Customer Notification

V850E/PH03

Operating Precautions

μPD70F3441

No. 14 ADC: When reading the ADCRnm registers asynchronously the conversion result from previous channel might be provided. (Specification change notice)

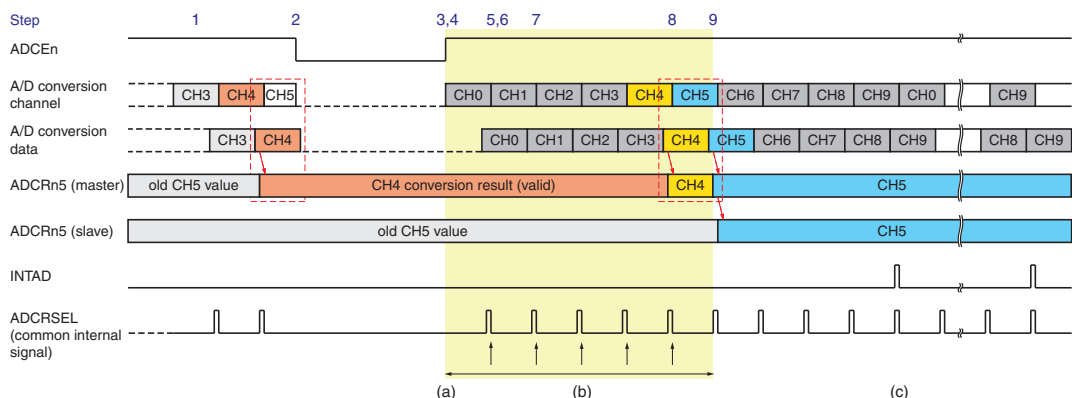
When the A/D converter (ADC) is operating in scan mode and is stopped asynchronously (by clearing the ADCEn bit, rewriting of ADMn0/ADMn1/ADMn2 registers, or an enabled external or timer trigger event) the internal current ADCRnm master register might be loaded with the conversion result of the previous converted channel.

After AD conversion restart (by setting the ADCEn bit, or automatically after rewriting of ADMn0/ADMn1/ADMn2 registers, or by the enabled external or timer trigger event) the ADCRnm master register still holds the conversion result of the previous converted channel.

When the concerned conversion result register (ADCRnm) is read during the conversion time, the conversion result of the previous channel may be read, if at that time the internal ADCRSEL signal is active (for an ADC clock period of 62.5 ns).

Because of the small timing window (62.5 ns), a consecutive read of same ADCRnm register will never result in two invalid values.

When the ADC is stopped asynchronously during scan mode operation apply one of the following three procedures when reading the conversion results after reconfiguration and restart of the ADC.

- Use DMA transfer to obtain AD conversion results (ADDMA register).
- Read ADCRn registers in a corresponding INTADn service routine.
- Synchronize the first read of ADCRn registers with the first occurrence of the INTADn interrupt after restart of the ADC (without applying an interrupt service routine)
 - Clear ADICn.IF flag during reconfiguration and check ADICn.IF flag before reading the ADCRn registers.
 - In case of external or timer trigger ensure that the period b/w two consecutive trigger events is greater than the scan period of all selected channels. (refer to precaution 15.8 (2) in UM)
